# Mobile Intel® Celeron® Processor on .13 Micron Process in Micro- FCPGA Package

Specification Update

*September 2004*

Document Number: 251309-022

**Figure 12. System Bus Reset and Configuration Timings**

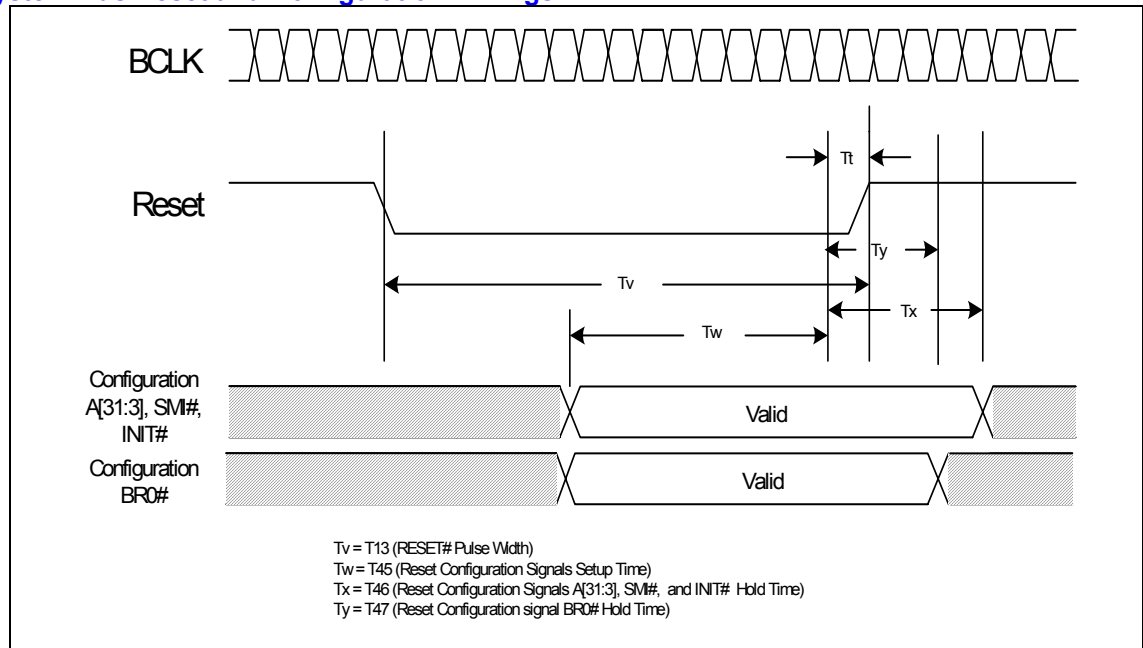
## 2. BR0# Maximum Hold Time Specification Change

The BR0# maximum hold time has changed to 2 BCLKs. This change will be shown in the “System Bus AC Specifications (Reset Conditions)” table and “System Bus Reset and Configuration Timings” figure of the *Mobile Intel® Celeron® Processor on .13 Micron Process in Micro-FCPGA Package Datasheet*. This change will be incorporated in the next revision of the datasheet.

The following figure is modified to reflect this change:

T# Parameter	Min	Max	Unit	Figure	Notes
T45: Reset Configuration Signals (A[31:3]#, BR0# INIT#, SMI#) Setup Time	4		BCLKs	13	1
T46: Reset Configuration Signals (A[31:3]#, INIT#, SMI#) Hold Time	2	20	BCLKs	13	2
T47: Reset Configuration Signal BR0# Hold Time	2	2	BCLKs	13	2
